APPLICATION NO.	FILING DATE	FIRST NAMED INVENTOR	ATTORNEY DOCKET NO.	CONFIRMATION NO.
10/690,080	10/21/2003	Ching-Hui Chi	2001064	4884

Office Action Summary

CHI, CHING-HUI

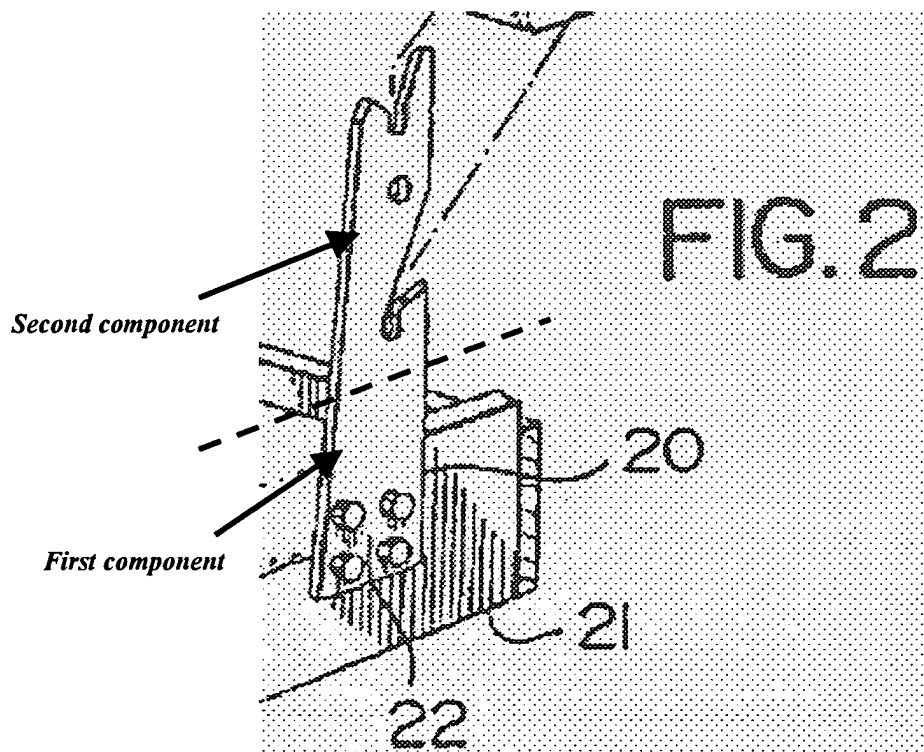
Boycott discloses a “furniture coupling system and method” comprising a pair of first supporting members 33 installed on both sides of the chair back, a pair of second supporting members 34 installed below the first supporting members on the chair back and a pair of supporting plates 20, which engage the first and second supporting members. Boycott’s supporting plates 20 can be divided into two components, as seen below. The first component includes at least one locking hole 22 for being fixed to the chair base 21. The second component includes a first concave portion cooperating with the first supporting member 33 and a second concave portion cooperating with the second supporting member 34. The first concave portion is located at an end opposite to the connection between the first and second component. The second component is located opposite to the first side. Furthermore, the second component includes a second locking hole 44 “for attaching the back 31 to the base 21 of the seating furniture” (col.3, lines 40-

41). However, Boycott fails to expressly disclose an angle between the first sides of the first and second components as being greater than 0 degree and less than 180 degrees. Yet, Crum teaches of such a design. Crum discloses a mounting bracket 20 having a lower portion 30 “for attaching the mounting bracket 20 to the base 5” and an upstanding link portion 33, “which is tapered toward its upper end” (col.3, lines 30-35). The figures disclose the “tapering” to be greater than 0 degrees and less than 180 degrees between the two components 30 and 33. Therefore, it would have been obvious to one having ordinary skill in the art at the time the invention was made to modify the first component of Boycott with a wider first component, as taught by Crum, for dispersing the load of the attachment of the plate therefore providing a stronger securement.
